# UNITED STATES PATENT AND TRADEMARK OFFICE

APPLICATION NO.	FILING DATE	FIRST NAMED INVENTOR	ATTORNEY DOCKET NO.	CONFIRMATION NO.				
10/696,932	10/30/2003	James F. McGuckin JR.	1255	1044				
7590 NEIL D. GERSHON REX MEDICAL 1011 HIGH RIDGE RD Stamford, CT 06905		<table border="1"><tr><td>EXAMINER</td></tr><tr><td>WEBB, SARAH K</td></tr></table>			EXAMINER	WEBB, SARAH K		
EXAMINER								
WEBB, SARAH K								
		<table border="1"><tr><td>ART UNIT</td><td>PAPER NUMBER</td></tr><tr><td>3731</td><td></td></tr></table>			ART UNIT	PAPER NUMBER	3731	
ART UNIT	PAPER NUMBER							
3731								
		<table border="1"><tr><td>MAIL DATE</td><td>DELIVERY MODE</td></tr><tr><td>08/30/2011</td><td>PAPER</td></tr></table>			MAIL DATE	DELIVERY MODE	08/30/2011	PAPER
MAIL DATE	DELIVERY MODE							
08/30/2011	PAPER

**Office Action Summary****Application No.**

## **DETAILED ACTION**

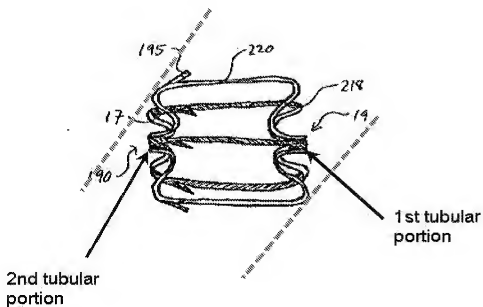
1. Applicant's arguments filed 6/22/2011 have been fully considered but they are not persuasive. Van der Burg is considered to meet the new claim requirements, as explained more thoroughly below. A tangent line is not required to extend perpendicular to the longitudinal axis, as indicated by the phantom lines drawn below. Therefore, the broad requirement is met by the Van der Burg filter.

Van der Burg discloses a vessel filter in Figure 35 comprising a plurality of elongated struts separated by cutouts. The struts extend parallel to the longitudinal axis and form a "mounting section." The filter is moveable between compressed and expanded configurations and Van der Burg explains that the device can be made of self-expanding material, such as Nitinol (column 6, lines 48-55). Each strut has bent regions at proximal and distal ends. The struts converge at both proximal and distal ends to form "filter sections" that terminate in tubular portions. As more clearly indicated in the drawing below, lines drawn *tangent* to the bent filter sections do not intersect the corresponding tubular portions at each end. A tangent line is not required to extend perpendicular to the longitudinal axis. For example, at least a portion of the phantom line drawn *tangent* to the first bend region is distal to the first tubular portion. Therefore, the first bend region is considered to be positioned sufficiently distal of the first tubular portion and the second bend portion is considered to be positioned
